PROJECT
719 JENIFER ST

SHEET NAME
ROOF PLAN & ELEVATIONS

From: Bradley Servin <b.servin@adcidesign.com>
Sent: Thursday, June 22, 2023 8:14 AM
To: Bailey, Heather
Subject: 18-037 : updated materials? (File Transfer - Ryan Reda - Home Addition - Madison, WI)

Project: 18-037 Ryan Reda - Home Addition - Madison, WI

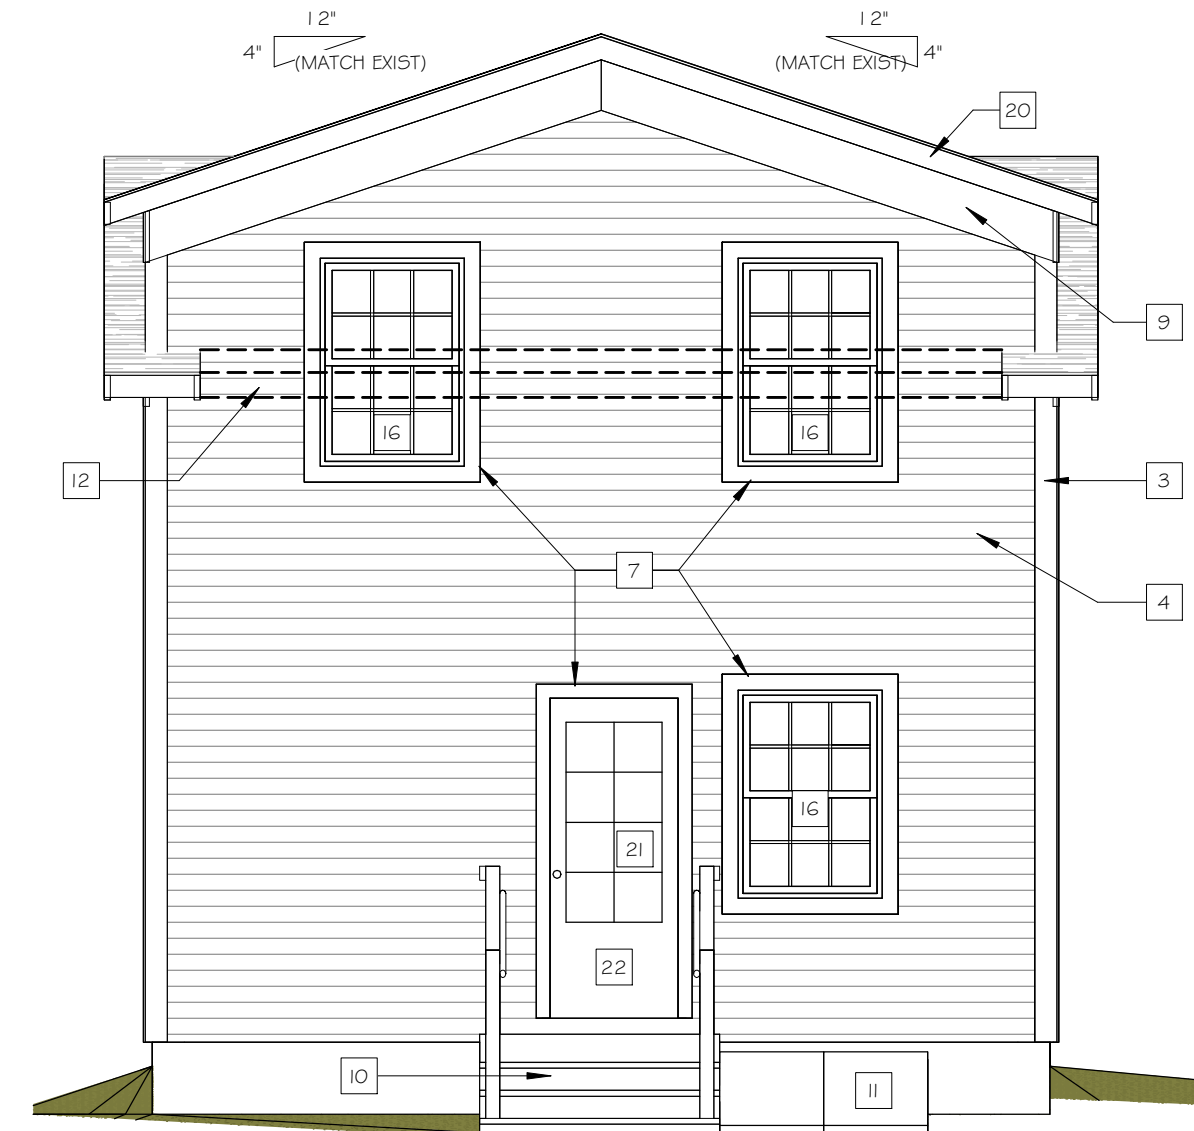
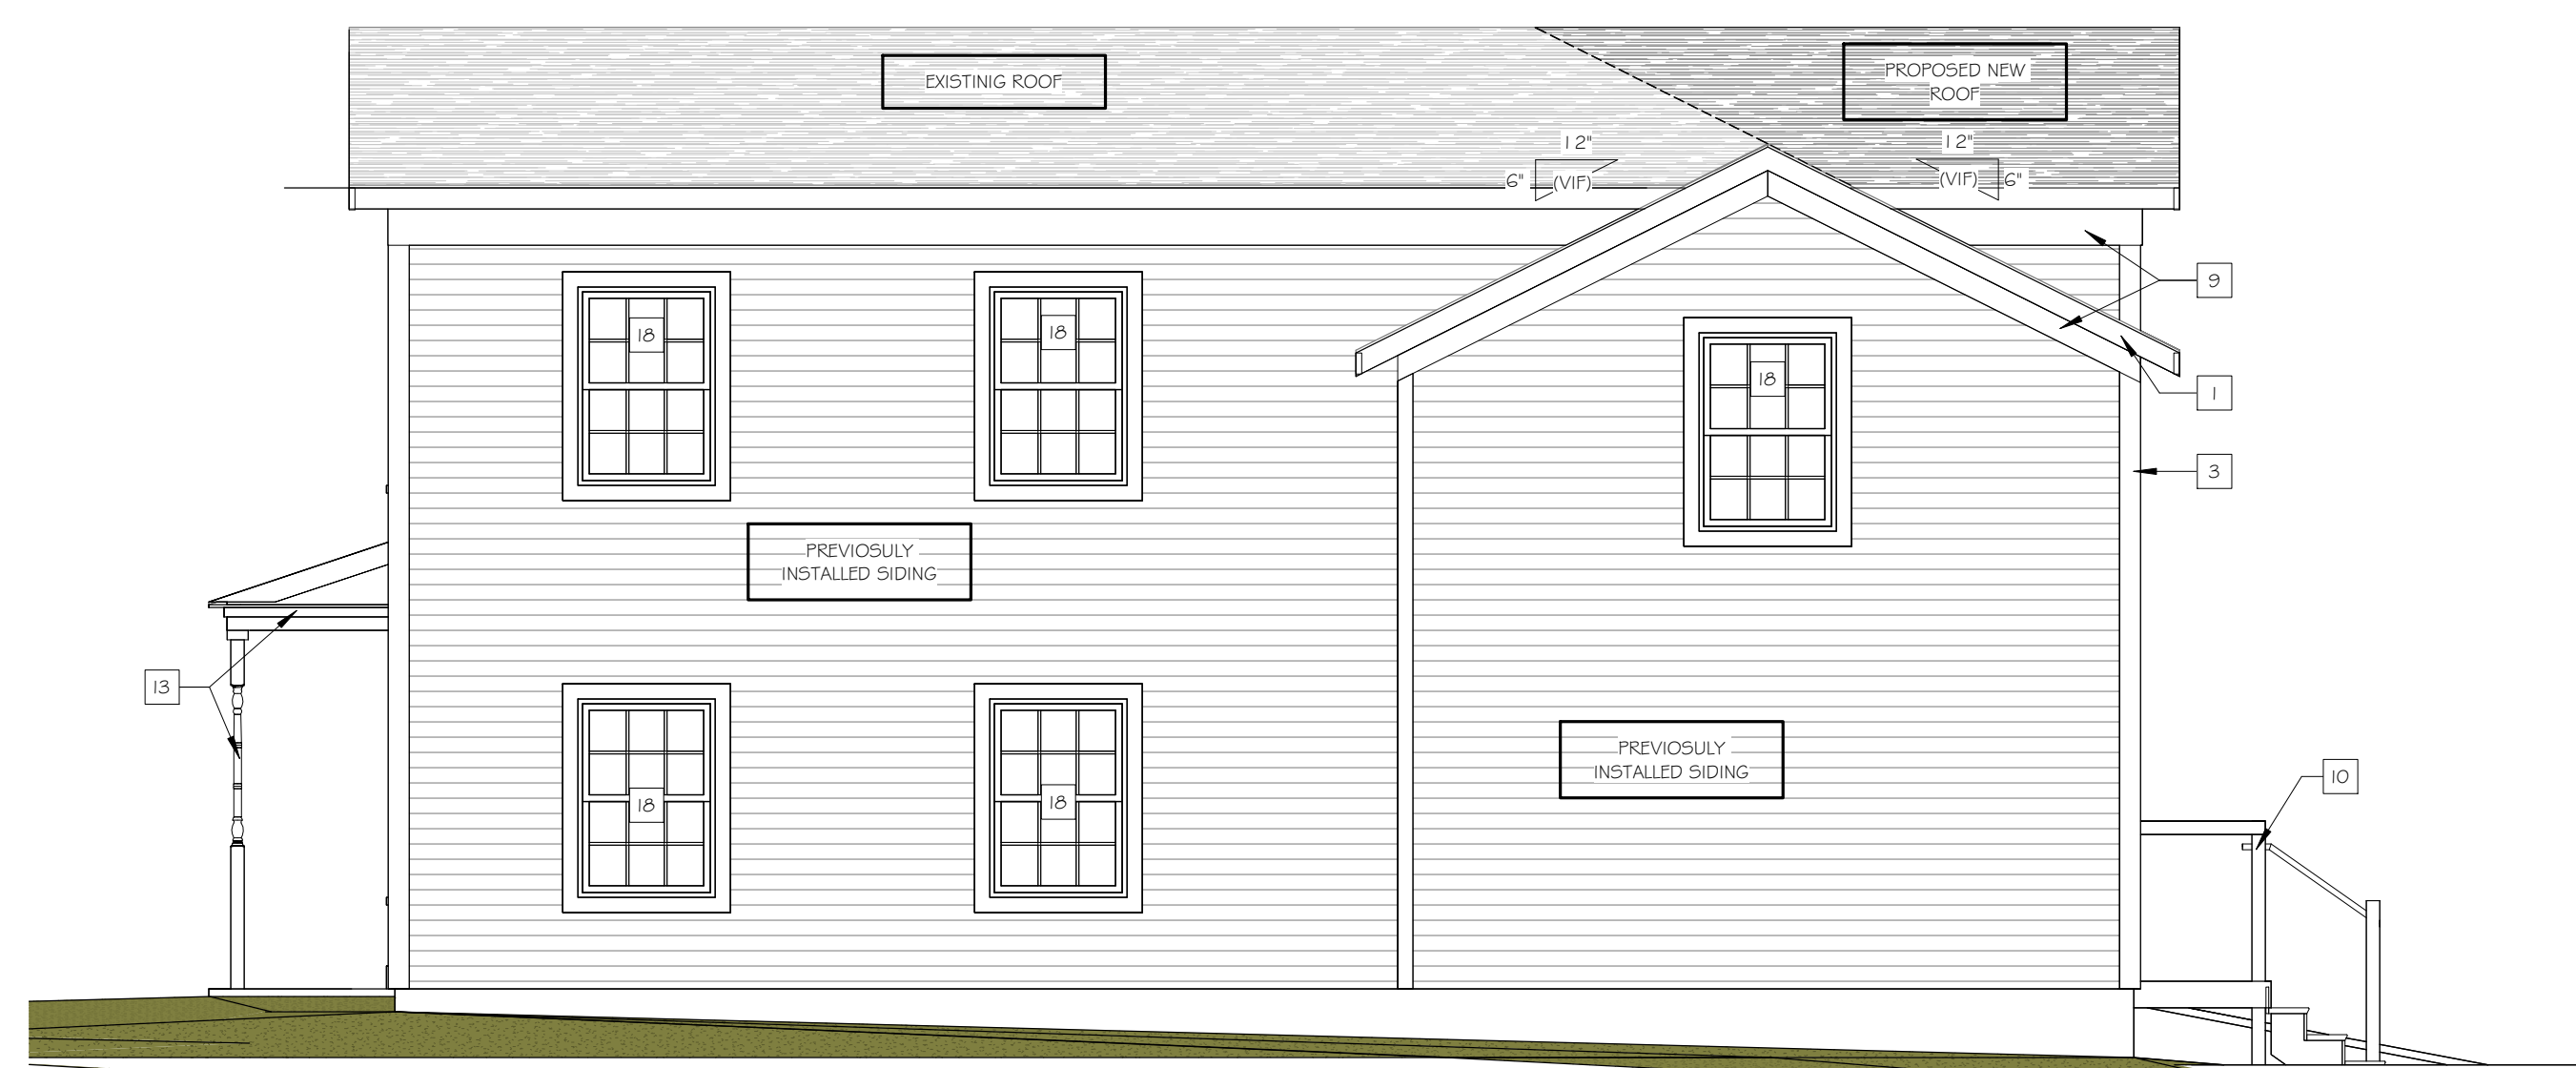
Note 10. We will need specs on the type of material proposed for the rear porch railing. **Rear porch railing basis of design is Azek Timber Tech Classic Composite Series: Color White – Cut sheet is attached**

Note 11. How are you completing the work for the rear basement access stair? Will this just be a new BILCO door? Or will this entail something else? **Attached are additional Photos of the basement access door. The door itself is in good condition and does not require replacement. The intent is the flash the door to the exterior building wall to create a water tight seal and repair the concrete slab around the door to create positive drainage way from the structure.**

Note 13. At our last meeting, I had asked for specific details on what all would happen with the front porch replacement and Ryan assured the commission that this only required some very limited replacement. If we're replacing the porch, we need specifics on what materials will be used and how that work will be undertaken. If there are only a few places that need splicing in material, that's another matter. **Attached are two closeup photos of the existing entry porch. As you will see the parts and pieces of the porch roof construction and supports or not off the shelf products. There are no specs to provide. The intent is to replace deteriorate members with in kind crafted pieces as required.**

Note 16. Your note says that the window will have a vinyl exterior. The previously supplied specs for the windows had an interior vinyl frame, but a metal clad exterior. Will this be the same type of window as previously installed or is this to have vinyl exterior? **I did visit the site this morning and confirmed the window exterior cladding is metal. I was of the impression that the exterior cladding was vinyl. All proposed windows are to be aluminum clad to match what was initially installed.**

Note 17. I think that the note for this item is incorrect as it talks about windows, but it denotes an area of fascia. **You are correct. The notes have been removed. New plan sheet attached.**

Note 18. Likewise, this material says that it is fascia, but it is clearly a previously replaced window. **You are correct. The notes have been removed. New plan sheet attached.**

Note 21. We'll need final specs on these. A new rear door and storm were proposed with the 2021 approval and I don't know if you're proposing that again or if you're looking at a different product. **The back entry door and screen have been separated with individual tags on the updated plans. With specific notes regarding product selection. Let me know if you need anything more.**
